Request to the Planning Assessment Commission

Watermark Coal Project

**QUESTIONS RELATING TO GROUNDWATER IMPACT ASSESSMENTS
WATERMARK PROJECT**

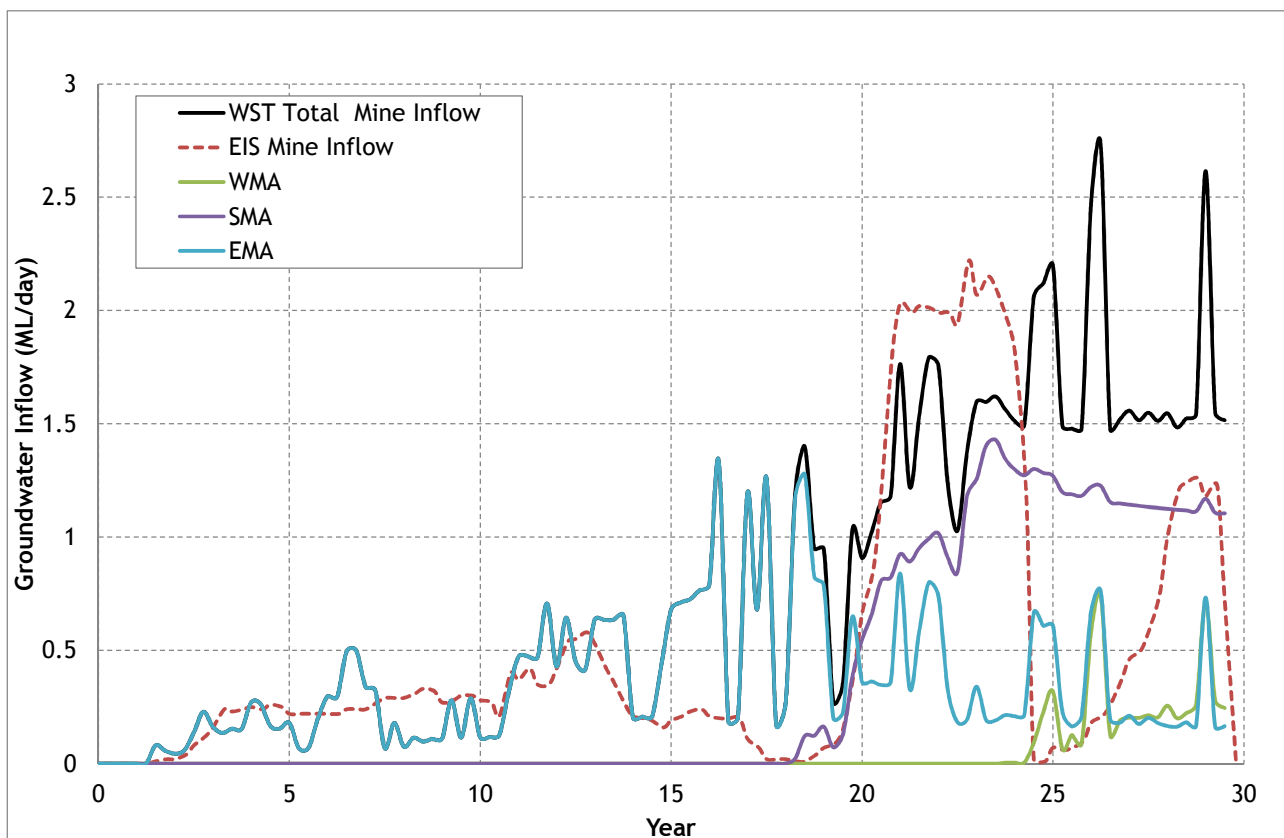
Question 8: Can the proponent provide a summary of mine water make to the different pits similar to Figure 10.6 for the WST model?

Answer: Provided below. It should be noted leaving the Eastern and Southern Pits open is not proposed by the client.

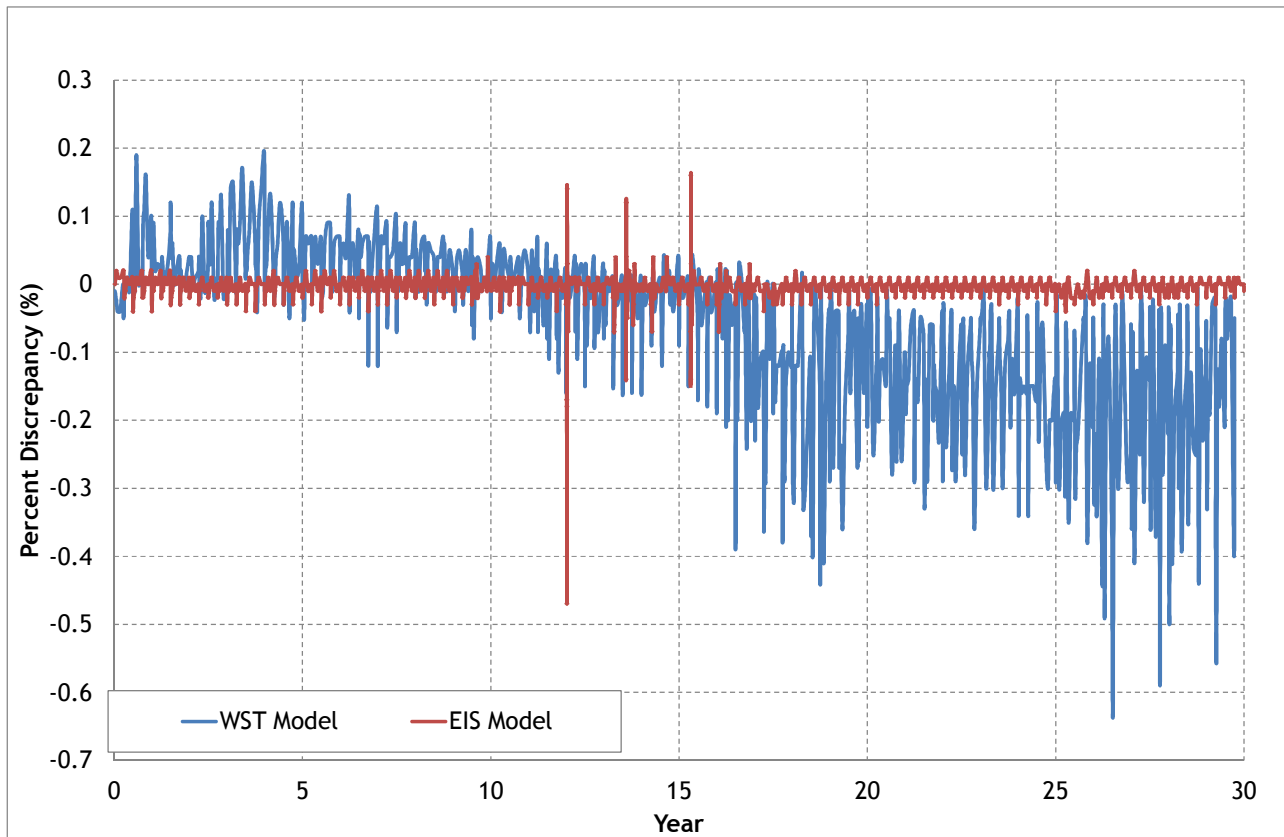
Question 10a: Were any similar comparisons of fluxes undertaken for the reported model?

Answer: The WST model provided to the Third Party Reviewer adopted a HCLOSE value of 0.1. This ensured the model ran quickly and we could provide drawdown results to the Third Party Reviewer promptly. The models reported in the EIS had much tighter convergence criteria to ensure volumetric water budgets were accurate. The percent discrepancies compiled were with the recommended limits in the Australian Modelling Guidelines of 1% for each stress period and cumulatively. The graph below shows the percentage discrepancy in the water budgets for the WST and EIS models and highlights the accuracy in the EIS water budget.
